PREVOST

IS-19071

WHEELCHAIR LIFT (WCL) HANDLE CLAMPS REPLACEMENT

First Release

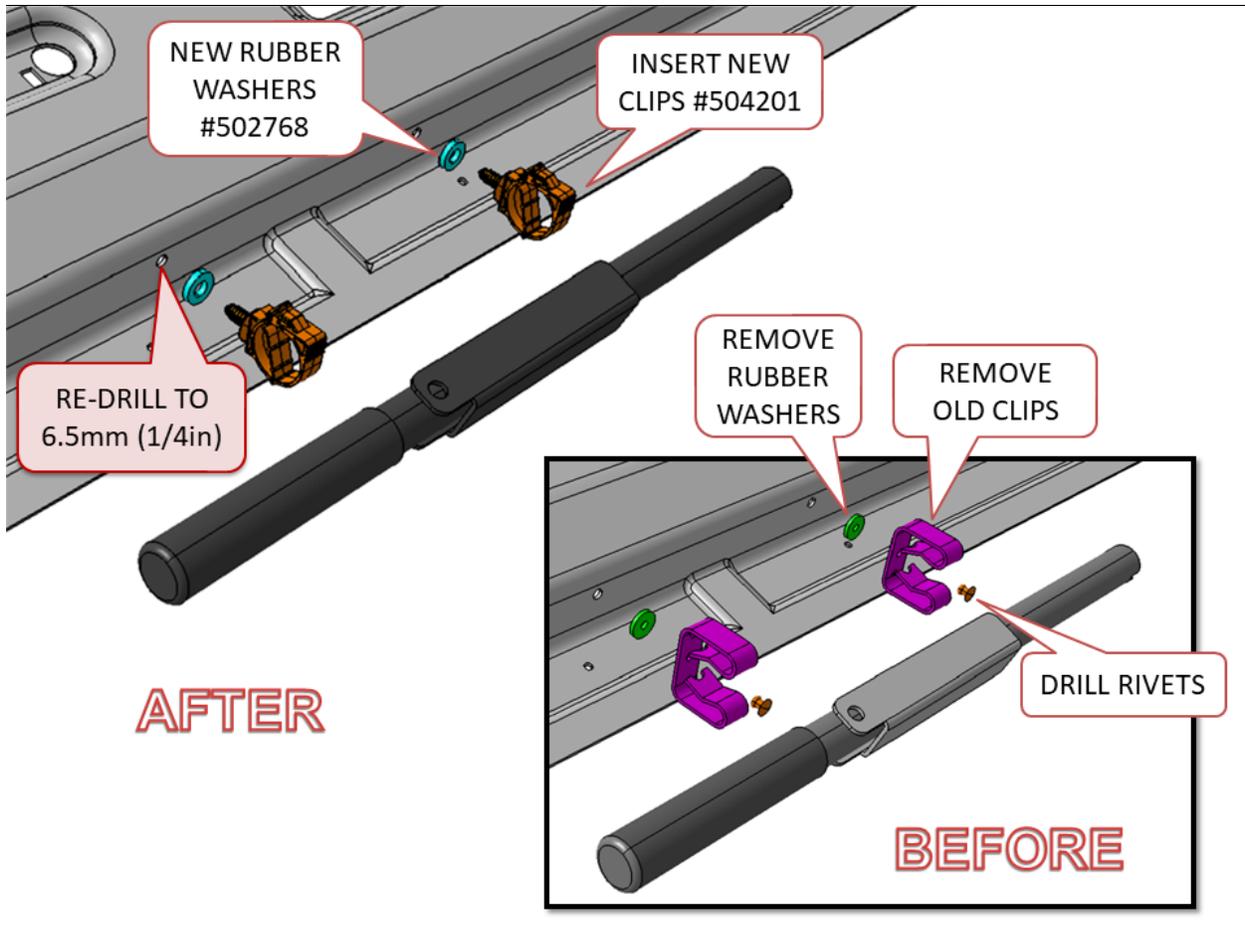
1. Install the new wheelchair lift (WCL) handle clamps.
 - Drill the head of the old clamps center rivets.
 - Remove & discard the old clamps.
 - Remove & discard the old rubber washers.
 - Re-drill the mounting holes in the door to 6.5mm (1/4in).
 - Press in place the 2 new **504201** clamps (install 2 new **502768** rubber washers under the clamps).
